HAWKS MILL needham market

working drawing - SHEET 4 of 6

Re: HAWKS MILL, NEEDHAM MARKET

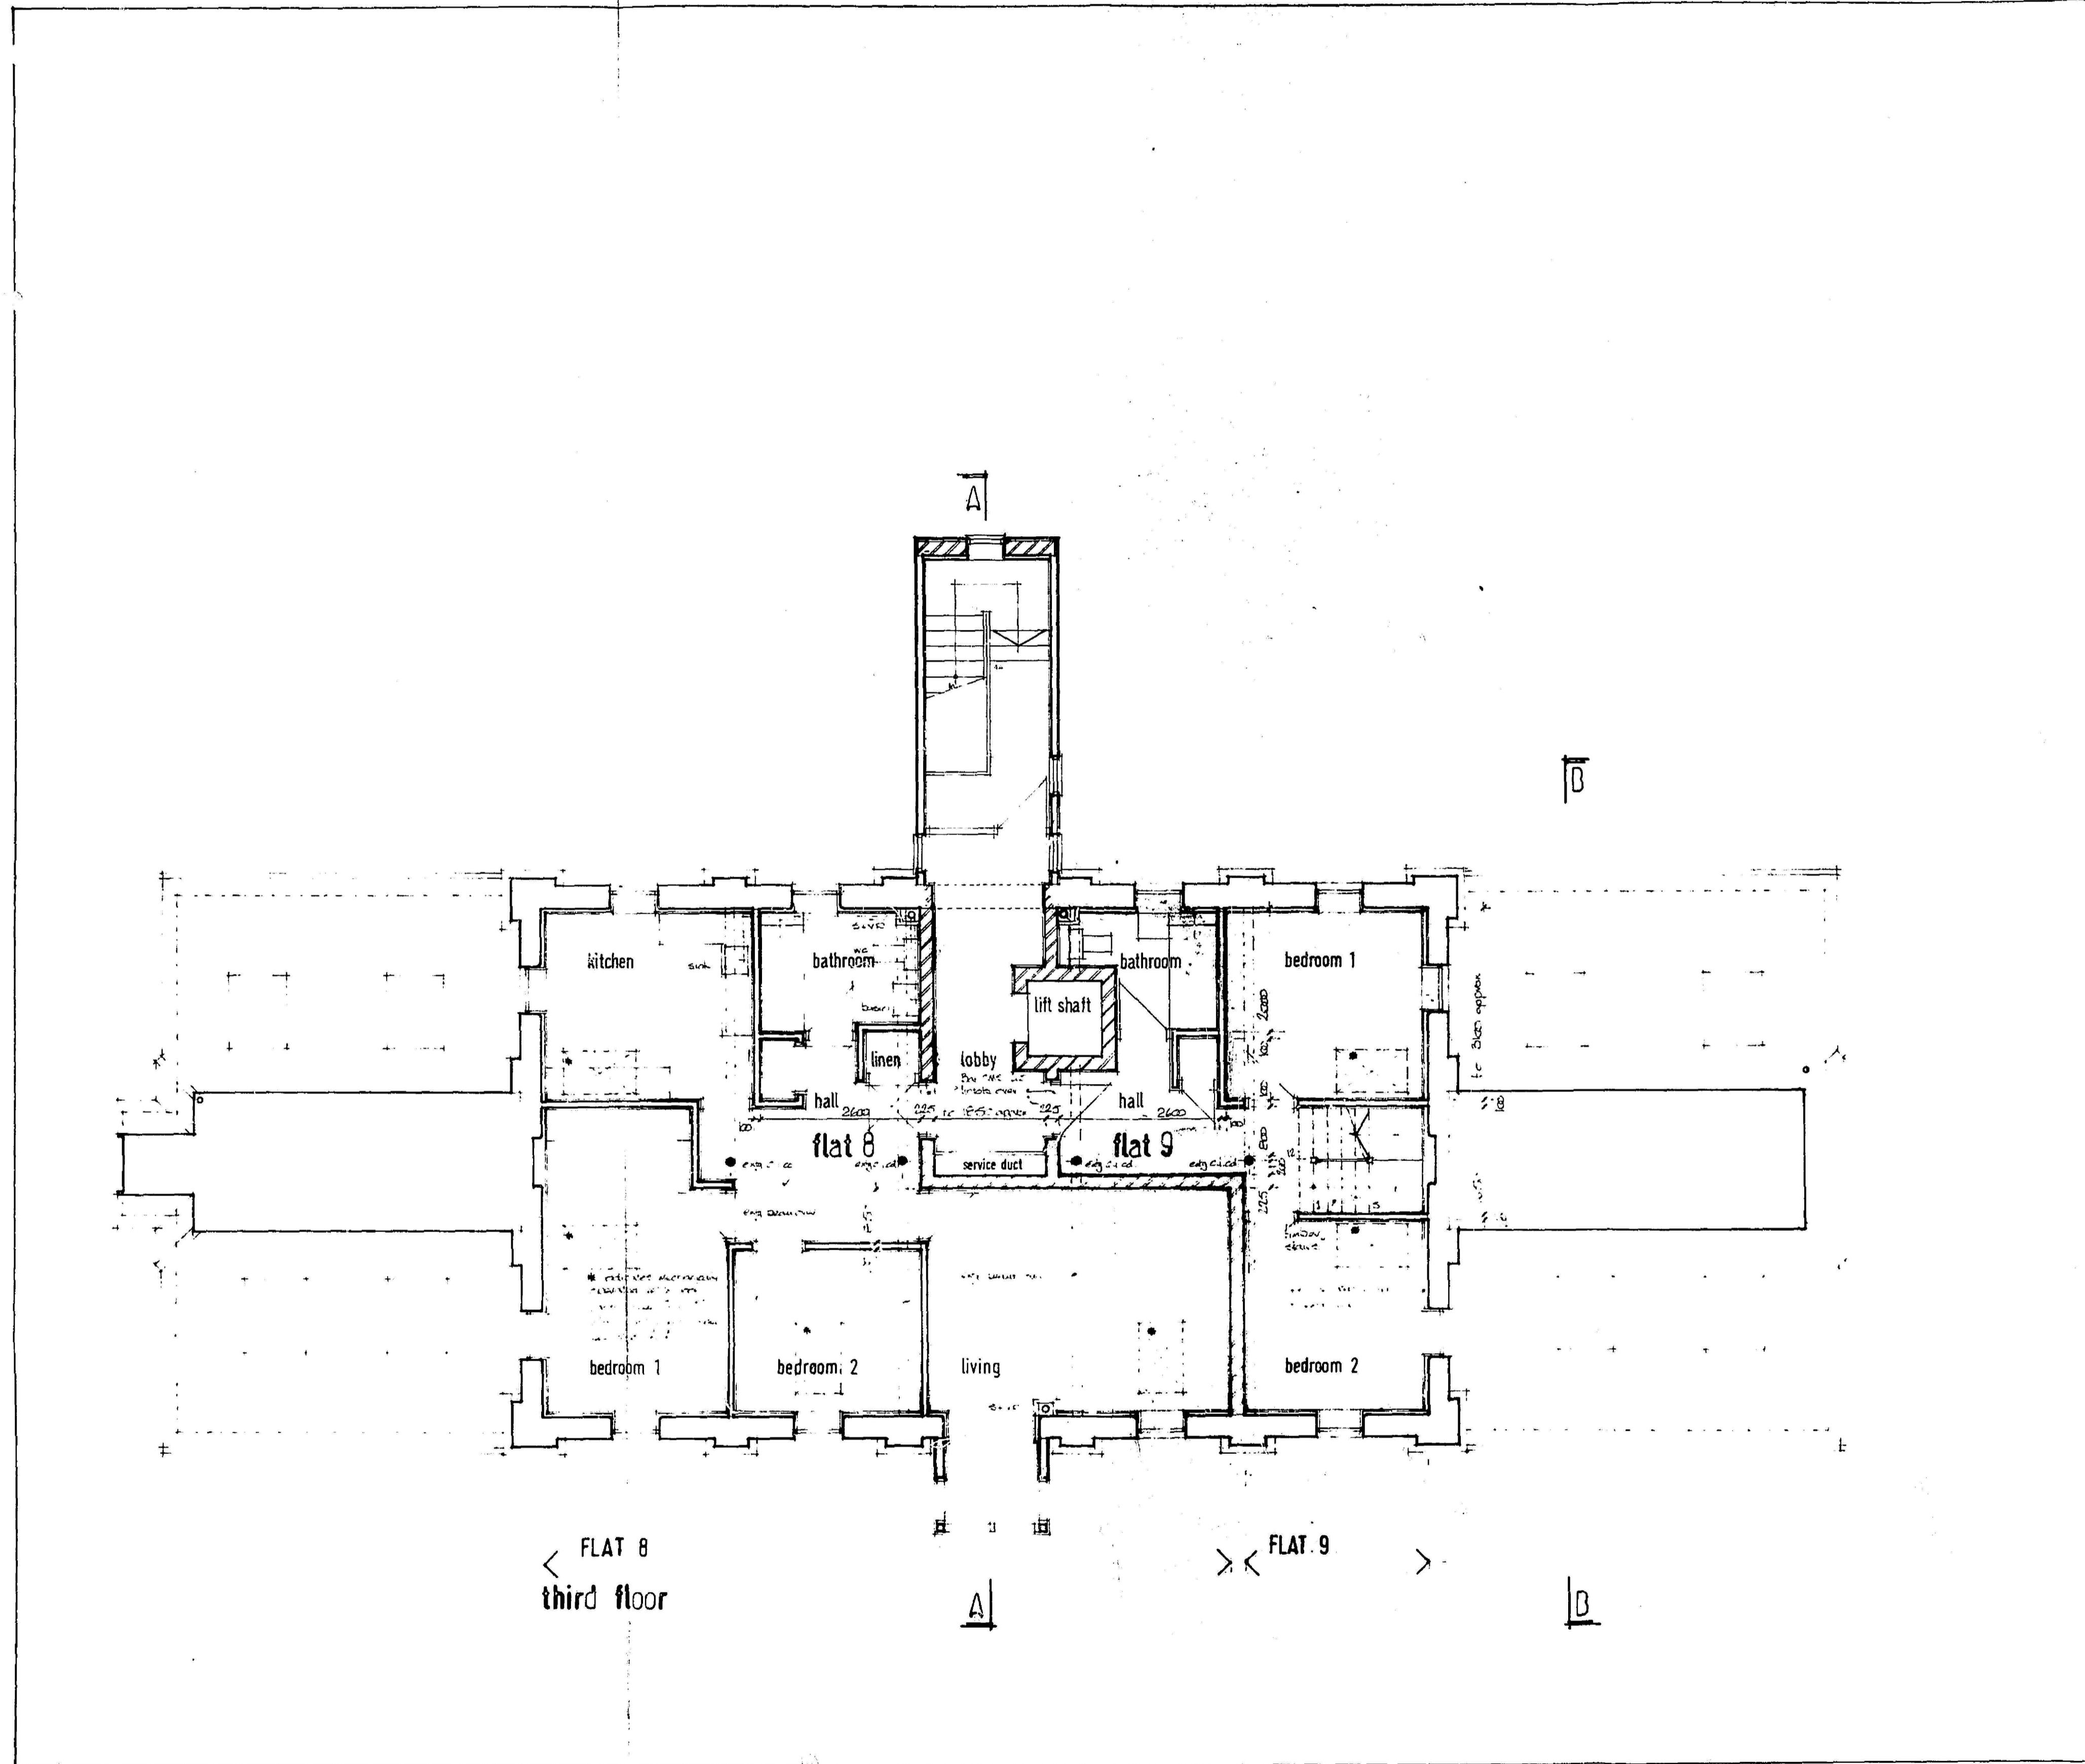
My attention has been drawn particularly to the central roof light on the eastern slope of the main Mill building. This roof light appears to be constructed on a plinth which lifts it above the plane of the roof slope. This is not something which was considered as part of the application, and I do not consider it a suitable way of inserting a roof light in the slope. When I first considered the conversion of the Mill, there were a small number of roof lights inserted in a dark slate roof. What I am now being asked to consider is a series of incremental changes which has resulted in a larger number of roof lights, not at all in the same position nor of the same shape and size as those originally approved, and with at least one raised above the level of the roof, in a roof which is a weathered concrete tile and therefore fairly pale in appearance. The entire character of this conversion appears to be changing for the worse, and I must therefore ask your client to reconsider the number, position, and size of roof lights on the building, together with the finished roofing material.

With regard to your third and penultimate paragraphs, the only variations to roof lights from the approved drawings, in the Mill, are as shown on drawing No. SK.1329-07, i.e. one additional light on the east elevation and slightly wider lights on the north elevation both of which you have agreed. Please refer to my letter 7.4.86. I can, however, confirm that the upstand to the additional rooflight on the east elevation is to be removed.

I note also that the upstand to the additional roof light on the east elevation is to be removed.
